Request For Information

RFI-069

Subject: BP3 Steel Reconciliation Conf
Project: Steamboat - BV BP Promenade and Goldwalk
Address: 2305 Mount Werner Circle
Steamboat Springs CO 80487 USA
Phone:
To: Jim Gray
Zimkor, LLC
From: Saunders Construction, LLC

1A-S5.03

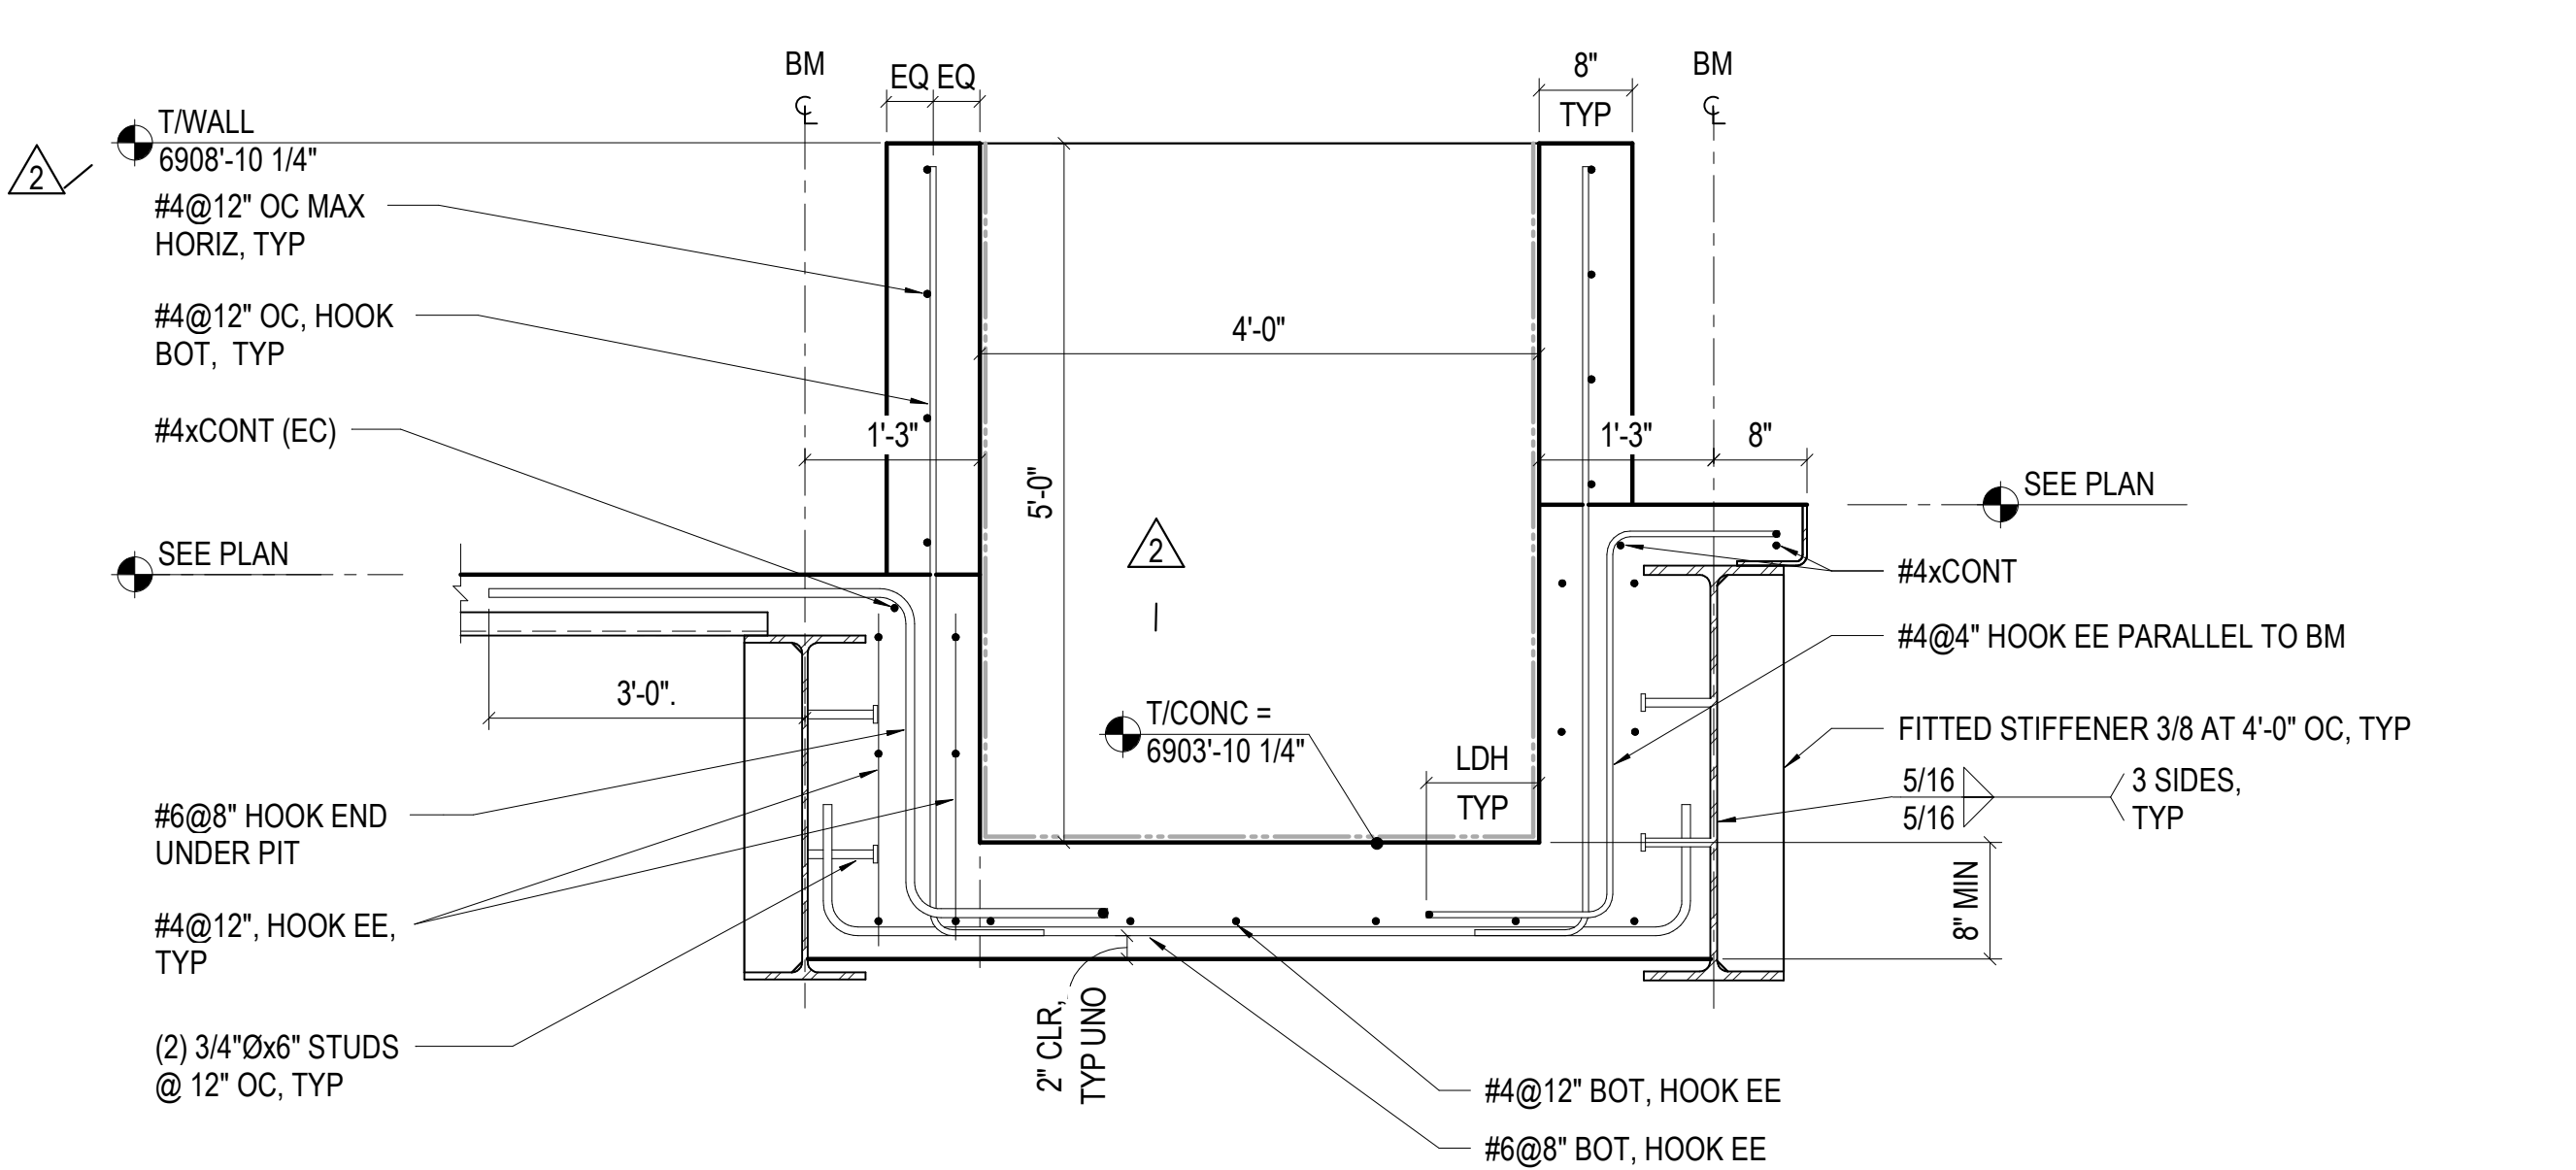
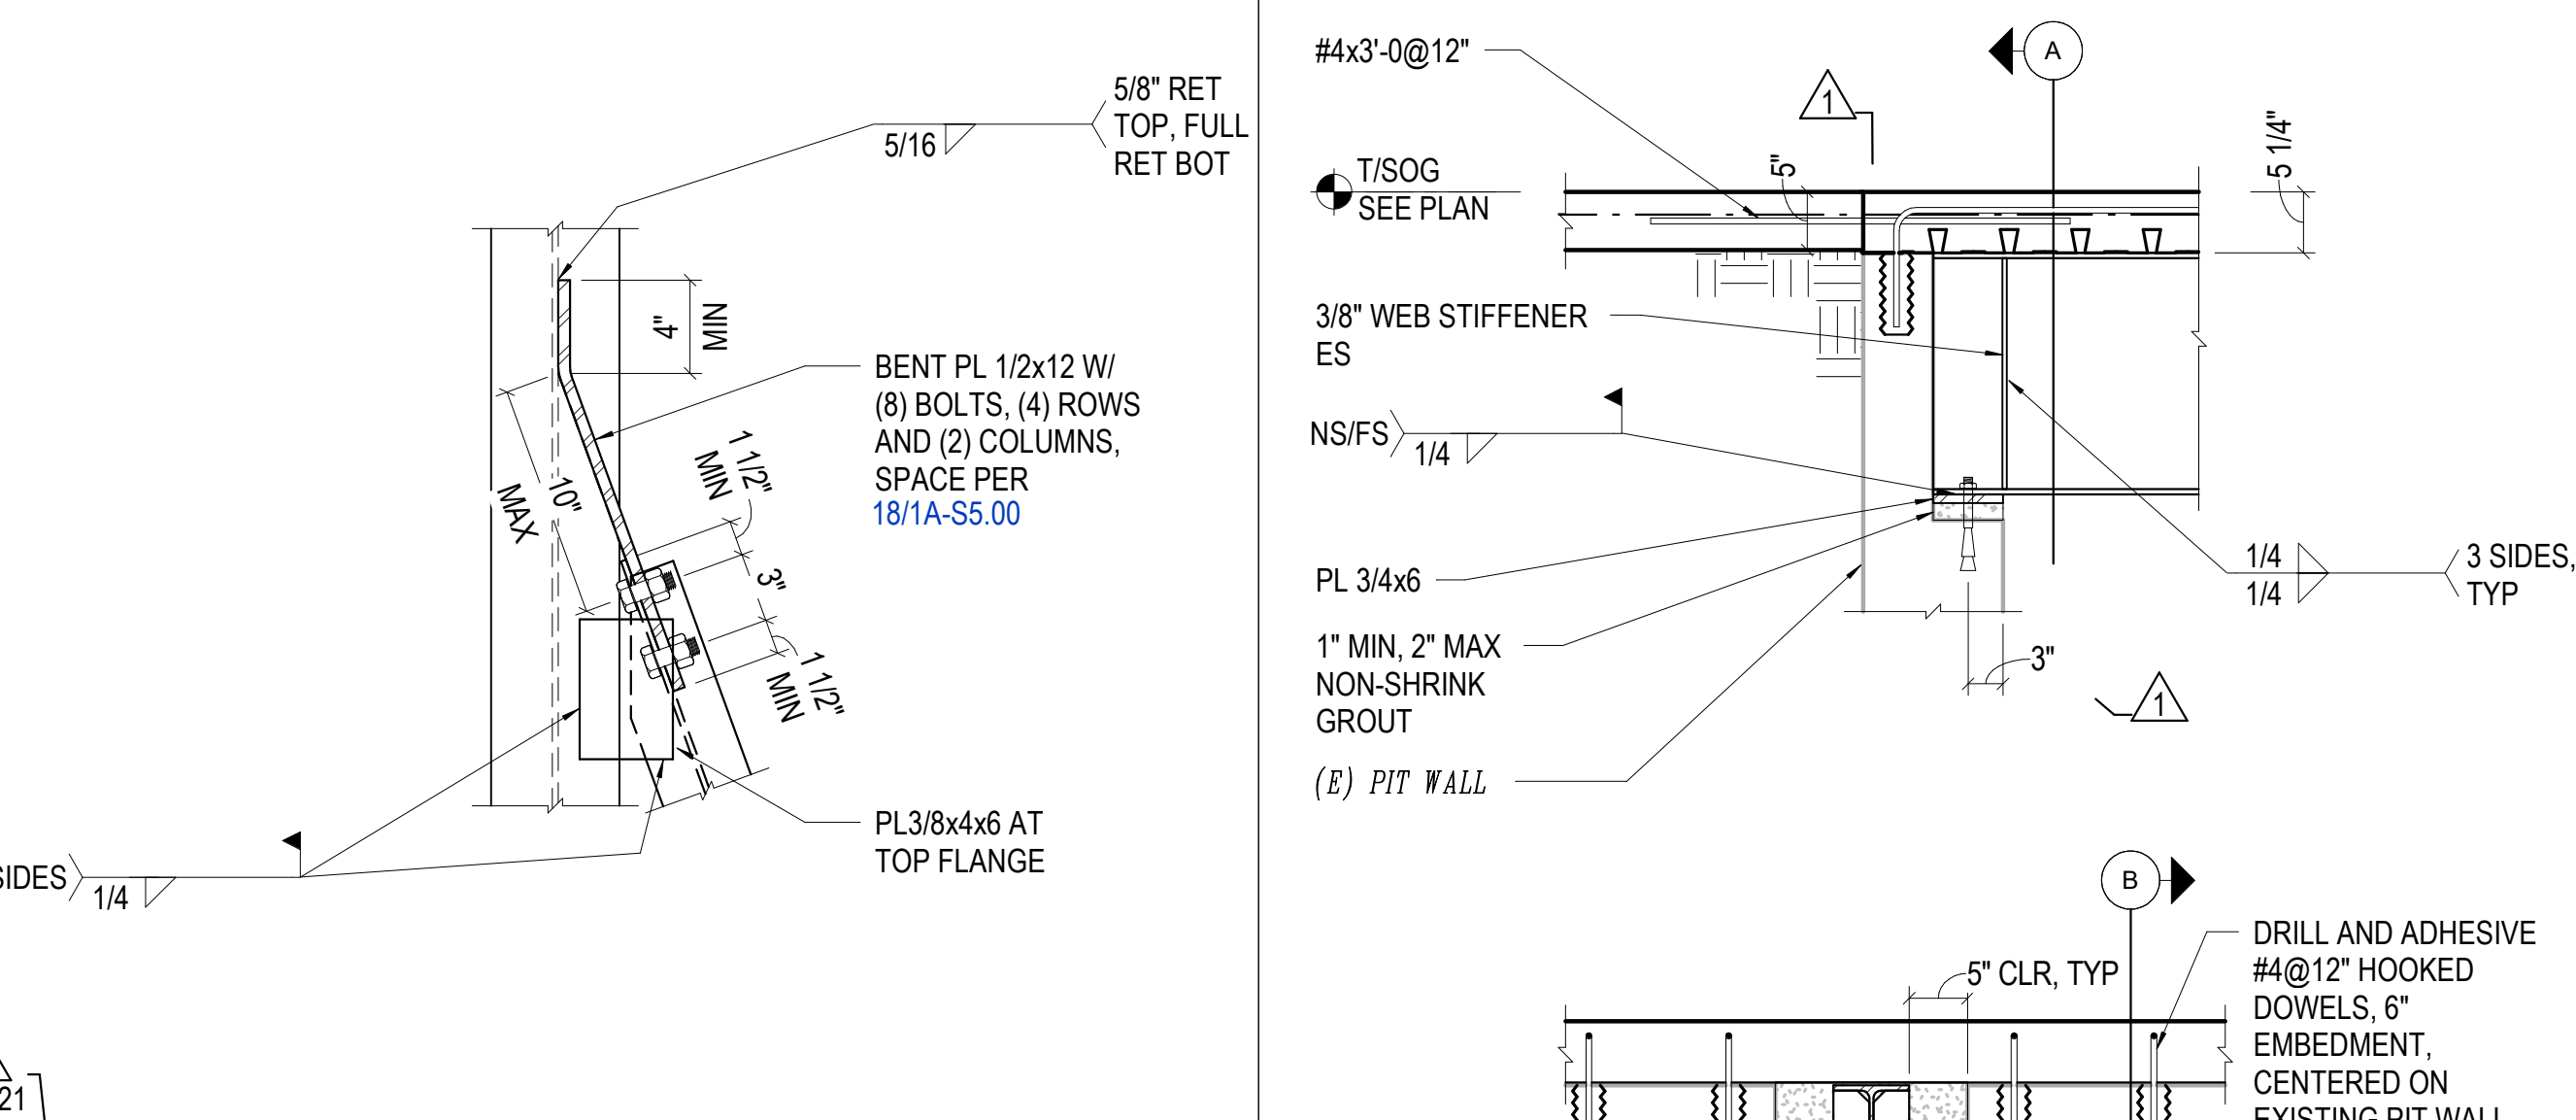
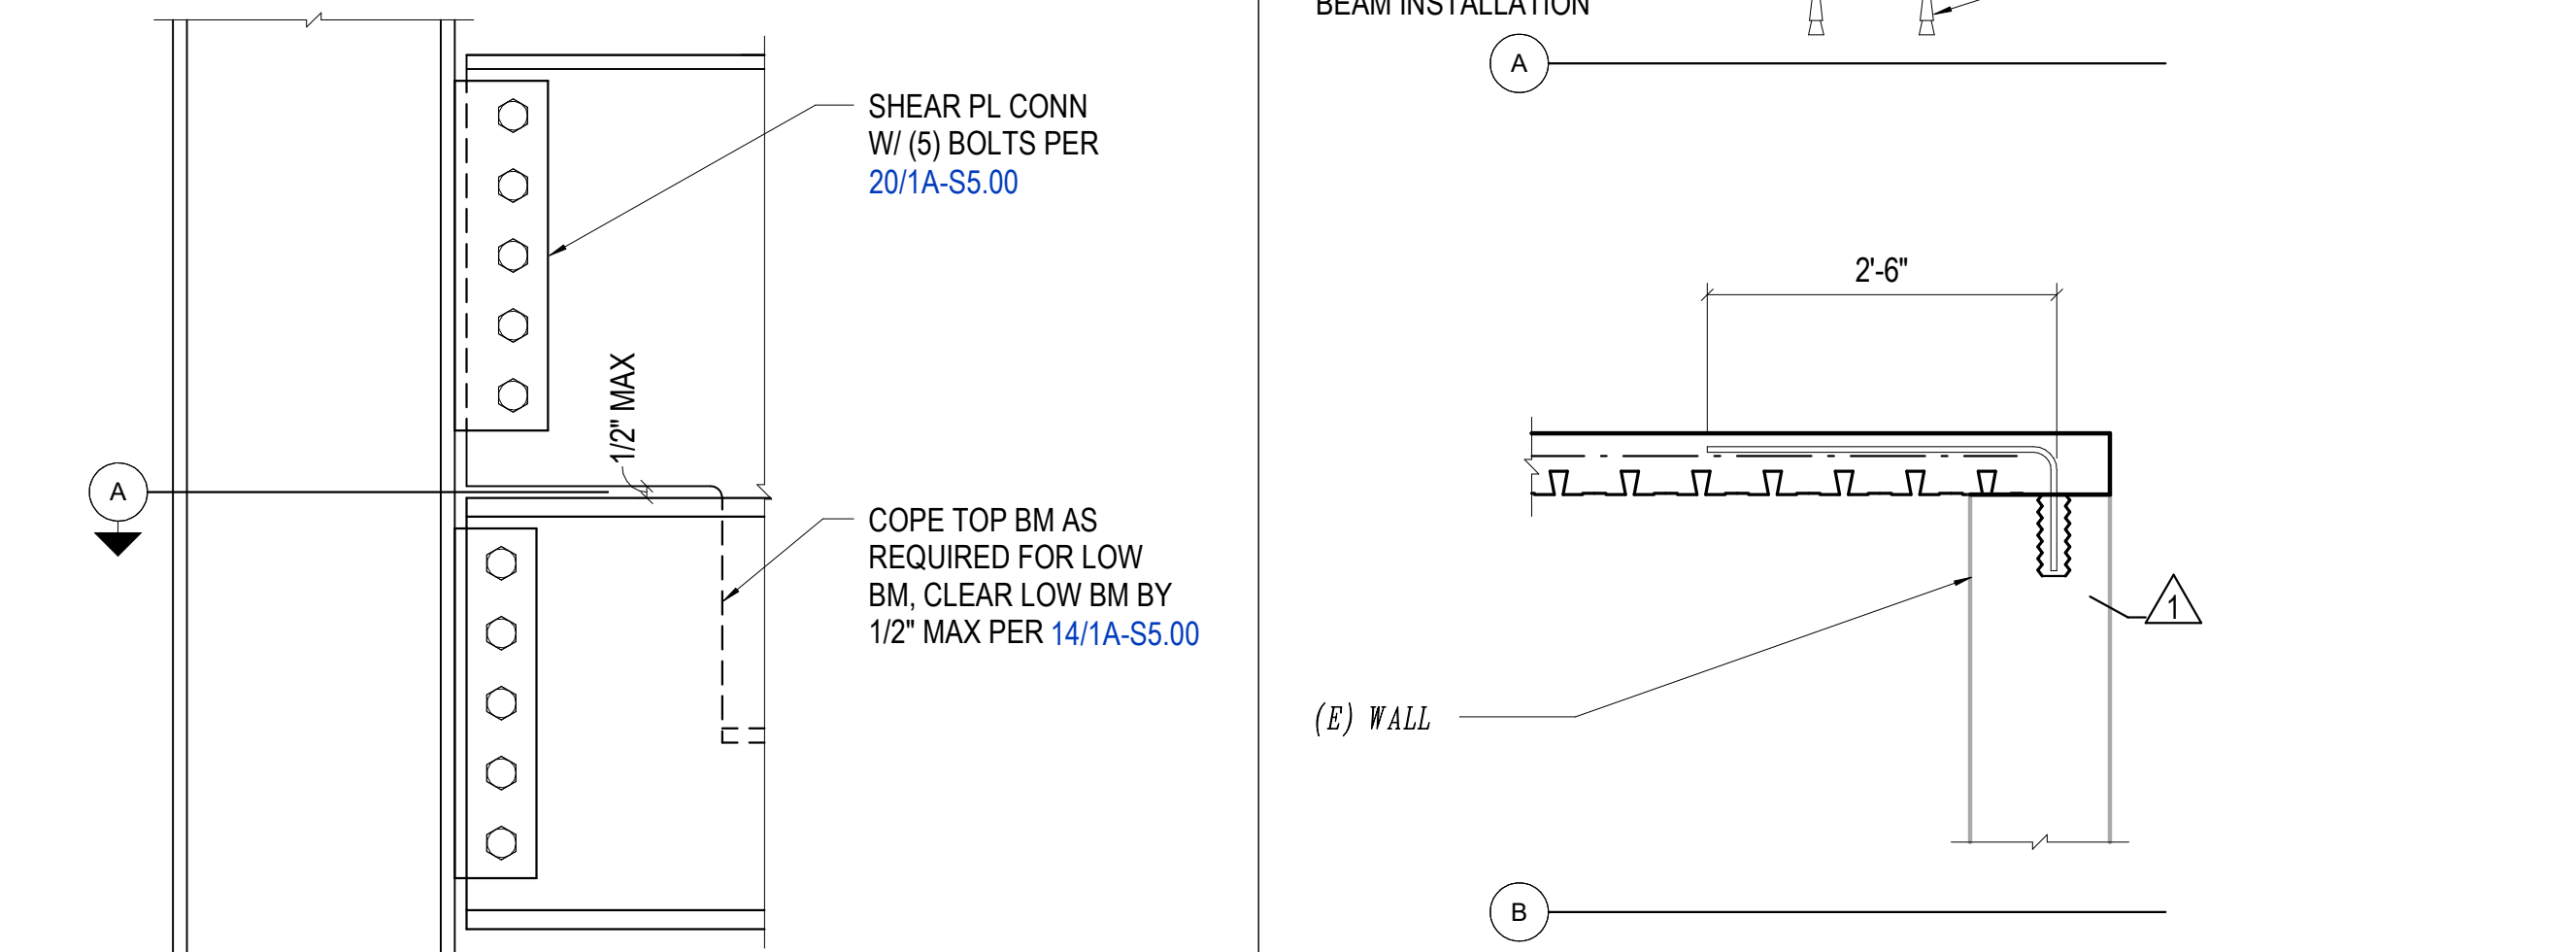
Following release of Promenade Bulletins 5 & 7 further structural steel and foundation changes were needed to be made in order to reduce schedule impact associated with design changes. Please confirm the attached print with updated sheets 1A-S1.00, S1.01, S4.01, S5.02, S5.03 and S5.30 is the final change document to be followed.

CONFIRMED.
KK/MM 8/19/21

SEE ATTACHED DRAWINGS WITH CORREC TITLE BLOCK
JAPPLE GENSLER 8/20/21
